Montgomery Planning

TREGONING PROPERTY PRE-PRELIMINARY PLAN NO. 720220020

No. 720220020

Completed: 2-13-2023

Figure 3 – Pre-Preliminary Plan with a Proposed Path Connection at the end of Hoffman Drive

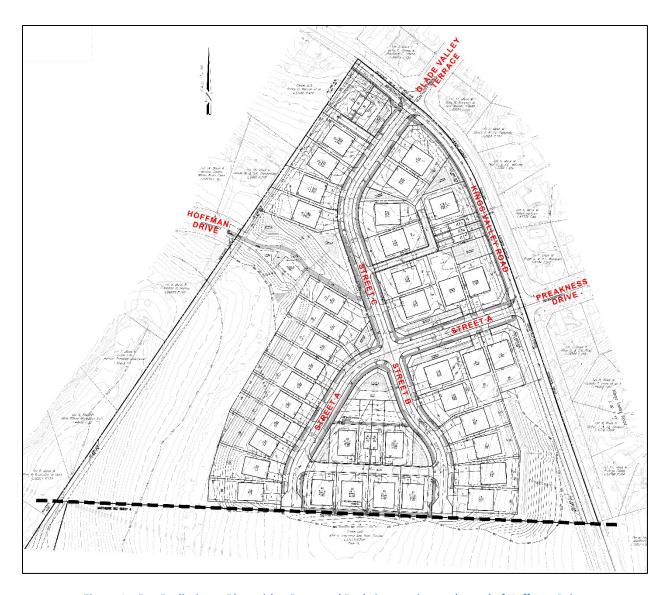
The Applicant proposes to construct a residential community on the Subject Property (Figure 3) between existing Hoffman Drive and Kings Valley Road. Hoffman Drive currently terminates in an unimproved condition at the western property line (Figures 4 and 5) that does not continue to connect to any public road. Without providing a continuing connection on the Subject Property, the existing Hoffman Road community, the new proposed community, and the existing Sweepstakes community along Kings Valley Road will remain disconnected. This disconnection would hamper access to Cedar Grove Elementary School and Damascus Recreation Park. As discussed below, the Applicant proposes to construct a shared use path (for bicyclists and pedestrians) between the termination point of Hoffman Drive into the Subject Property (as opposed to a full road connection with vehicular access) to limit

The Applicant does not propose to extend Hoffman Drive as a full road connection. Instead, the Applicant proposes to connect Hoffman Drive to the proposed development with an asphalt shared use path. The path would run between the existing terminus of Hoffman Drive to proposed Street C (Figure 6). This would accommodate bicycle and pedestrian connectivity between the proposed community and Hoffman Drive but would not accommodate vehicular connectivity. The path would be owned on private property and maintained by the future HOA as a recreation facility.

Staff recommends that the Applicant provide a full road connection to extend Hoffman Drive through the Subject Property to Kings Valley Road (Figure 7). Staff is additionally requesting at least one alternative road alignment that would connect to Kings Valley Road at the existing Preakness Drive intersection. The connection will provide an important link in an area with very limited connectivity, linking the Hoffman and Sweepstakes communities together as well as improving multimodal connectivity to Cedar Grove Elementary School and Damascus Recreational Park (Figure 7).

Figure 4 – Possible Hoffman Drive Connection

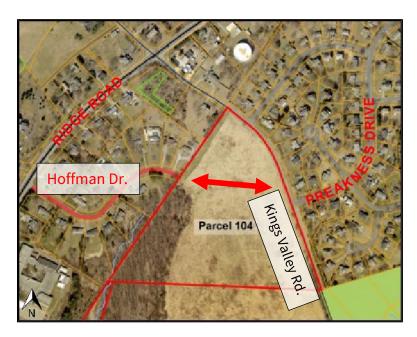
The proposed Hoffman Drive connection helps to alleviate these concerns and supports greater connectivity and a more complete community. The extension will help stitch together three communities – those along existing Hoffman Drive, the proposed subdivision, as well as the larger Sweepstakes community north and east of Kings Valley Road. Additionally, the road connection will accommodate improved access to Grove Elementary School to the west, immediately south of Hoffman Drive, as well as Damascus Recreational Park to the southeast (Figure 7). Currently, there is no safe bicycle or pedestrian link between these communities and the school, while vehicular connectivity is limited.

Staff therefore recommends the extension of Hoffman drive as a full road connection. This extension best aligns with Master Plan and General Plan vision, improves areawide connectivity, improves access for emergency and maintenance vehicles as well as to public facilities, and addresses noted deficiencies with the existing road termination.

Figure 10 – Draft Proposal from Applicant for Hoffman Drive Connection

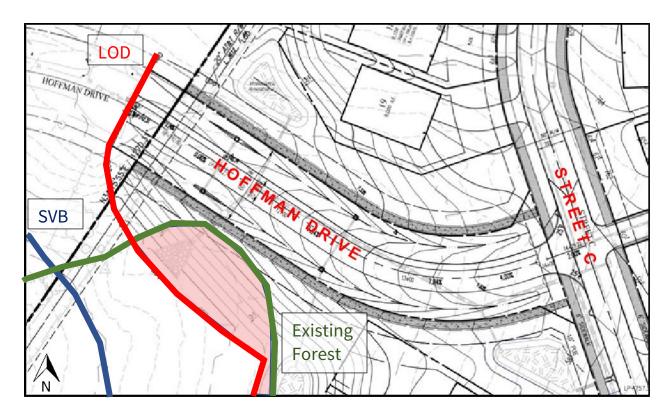
Staff acknowledges concern over grading and potential environmental impacts for the road alternative connection. As detailed in a draft road design provided by the Applicant, grades appear below eight percent and roughly in line with the existing grade of Hoffman Drive. Indeed, the shared use path alternative proposed by the Applicant meets ADA grading requirements, which are much stricter than road grade requirements, without the need for switchbacks or extensive regrading.

Similarly, the area potentially disturbed by the road connection (red line) appears distant enough from stream valley buffer (SVB) areas that there does not appear to be any impact to that key environmentally sensitive area (blue line). However, there may be limited impact to existing forest area (delineated in green), potentially impacting approximately 1/10 acre (shaded red). Beyond this impact, the potential grading required for the road does not appear appreciably different from the grading proposed by the Applicant. The Preliminary Plan review will also ensure that any impacts are minimal and meet all local and state requirements.

Figure 11 – Offsite Path Connection to Park

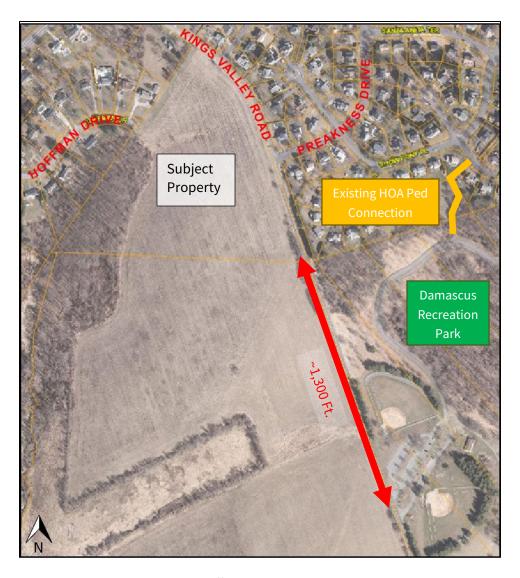
The Applicant proposes that future residents use the existing pedestrian connection within the Sweepstakes community HOA (Fig.11). The Applicant supports the broad concept of improving bike and pedestrian connectivity to the park but contends that it is not the responsibility of this application to finance and construct the facility. The Applicant contends that such a requirement is not clearly directed in the Subdivision Code, Zoning Code or master plan and is not a frontage improvement as it is offsite from the Subject Property. The Applicant expresses concerns over the proportionality of the improvement in comparison to the size and impact of the proposed development, with particular concern that the existing grade along a country road would complicate construction. The Applicant states that the need is not clear as neither the *Clarksburg Master Plan* nor the 2018 *Bicycle Master Plan* recommends a bikeable path along Kings Valley Road.

Staff requests the Applicant construct an ADA accessible paved shared use path connection along the west side of Kings Valley Road. Staff recommends this alternative to best serve the proposed community with a direct bicycle and pedestrian link to the Damascus Recreational Park, an important area recreational center that contains a variety of outdoor sporting and playground facilities as well as an extensive internal trail network. As proposed, the path would extend from the southern end of the Subject Property, running along the west side of Kings Valley Road (red line, Figure 11), and crossing the road opposite to the northern parking lot at a location that is planned for a future crossing of master-planned trail connection to Ovid Hazen Wells Recreation Park to the west. The exact crossing location is to be determined in conjunction with staff from Montgomery Parks, Planning, MCDOT, and DPS to ensure safe crossing of the road, with sight distance analysis to be conducted by the Applicant in support of the review.

Staff recommends construction of this off-site path connection. The path will provide an important bike and pedestrian link which will increase access to Damascus Recreation Park and improve safety. Staff believes this connection is a logical connection that is reasonable in scale to the proposed development.

Figure 13 – Existing Path from Sweepstakes Community

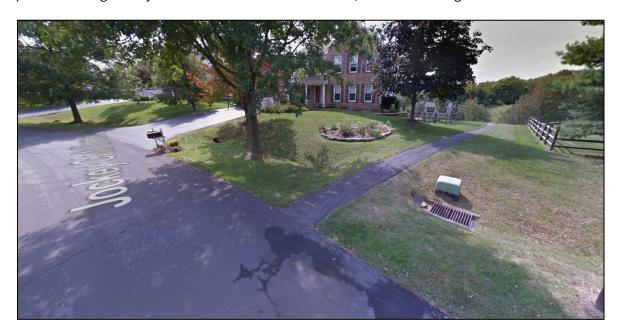
Moreover, the connection is not suitable for users with mobility limitations as it follows stairs to access the park, is narrow by current standards, and offers no signage to indicate connection to the park. Additionally, the path traverses non-public HOA property; public access rights are not expressly granted in the land records for this connection. As a result, this connection is not seen as an acceptable primary public access point to the park from the proposed application community.

Figure 14 - Pre-Preliminary Plan Layout with MPDUs

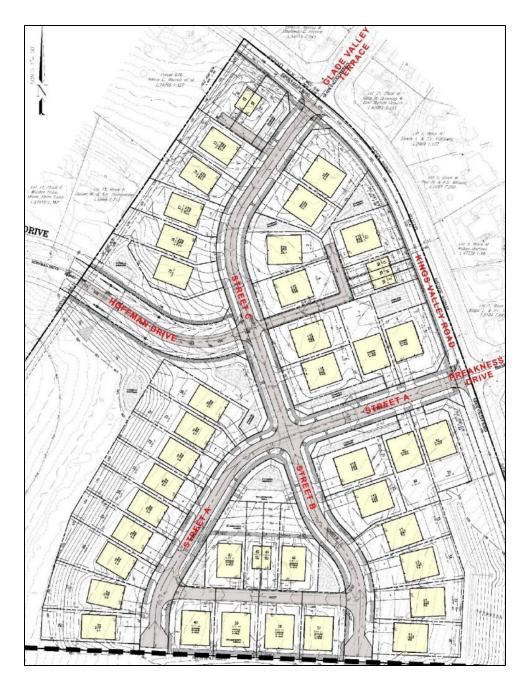
The Applicant initially proposed to provide the seven MPDUs within a solitary row of townhouses that were isolated at a single location overlooking an open space encumbered with stormwater management facilities. Staff expressed concerns about the lack of distribution of the MPDUs in relation to the market rate units on the Subject Property. Subsequently, the Applicant team submitted revised layouts which distributed the MPDUs throughout the proposed development. The MPDUs were also incorporated as two duplexes and a single triplex, rather than the initial townhouse units.

As discussed above, Staff worked closely with the Applicant team on the layout and distribution of MPDUs on the Subject Property. The current layout has the MPDU units broken up and distributed across the Subject Property as two duplex units and a single triplex unit. DHCA is supportive of the efforts by the Applicant team and Staff to address the location, distribution, and massing for the MPDUs (Attachment F) on the Subject Property. Additionally, the MPDUs must incorporate building massing for the duplex and triplex units that is substantially similar to the proposed massing for the market rate single-family detached dwelling units. The distribution and massing of the MPDUs will better integrate them within the development, as well as make them visually compatible with the proposed massing for the single-family detached dwelling units.

Additional review comments provided by Staff are to be addressed within subsequent future applications. The single-family dwelling units should be oriented towards the street and provided as a mix of front-loaded and rear-loaded units, particularly within the northeastern block along Kings Valley Road. Providing a mix of front-loaded and rear-loaded units affords an opportunity for the rear-loaded units to frame the street and provide an edge and front for Kings Valley Road, the proposed internal streets, and the proposed open space. As proposed, most of the single-family detached units have been solely configured as front-loaded units with long driveways.

Staff requests that the proposed open space be enlarged to provide a grander, more meaningful open space for residents and visitors. Given that there is only the proposed central open space, the stormwater management facilities should be designed, located, and integrated within the open space in a manner that maximizes the overall amount of usable open space. Staff requests that the site grading be minimized in a manner that avoids the visual appearance of uniform grading, particularly around the southwestern and southeastern edges of the proposed development. Providing limited, strategic grading provides a more 'natural' and irregular appearance, as well as reducing the amount of site disturbance to the Subject Property. As discussed above, Staff requests that the Hoffman Drive connection be made to provide better connectivity for residents and visitors. It is critical to note that the final site layout will be directly impacted by the final alignment of the Hoffman Drive connection. The potential impacts will be to lot placement, single-family detached dwelling unit orientation, and site grading.

- 7. The Applicant must provide MPDUs as duplex or triplex units that closely resemble single family detached units in terms of massing and architecture, dispersed throughout the Subject Property.

Attachment C: Hoffman Drive Connection Exhibit

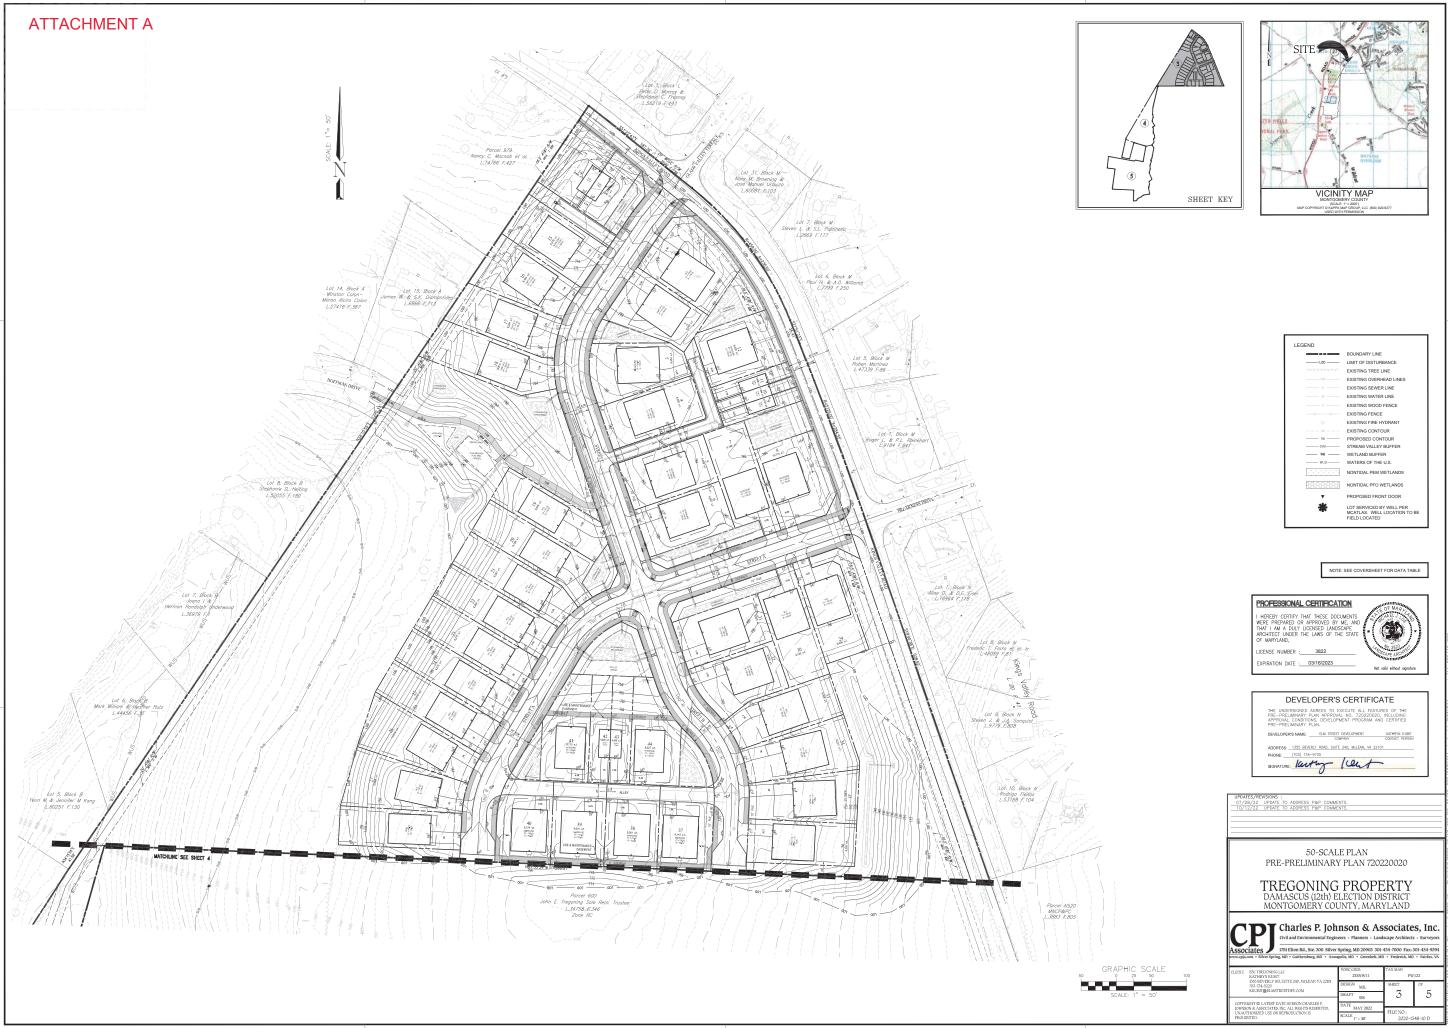
- c. 19-Hoffman Dr Exhibit:
 - i. We <u>agree</u> with the overall proposal of Hoffman Drive extension as shown. However, additional information (i.e., vertical grades, horizontal centerline, sight distance, roadway cross section, etc.) will be required at the Preliminary Plan stage for our review and approval of the extension.

- ii. Since the existing Hoffman Road is an open section, the proposed extension shall be per MC-2002.04, unless a modification is approved by MCDOT at the preliminary plan stage.
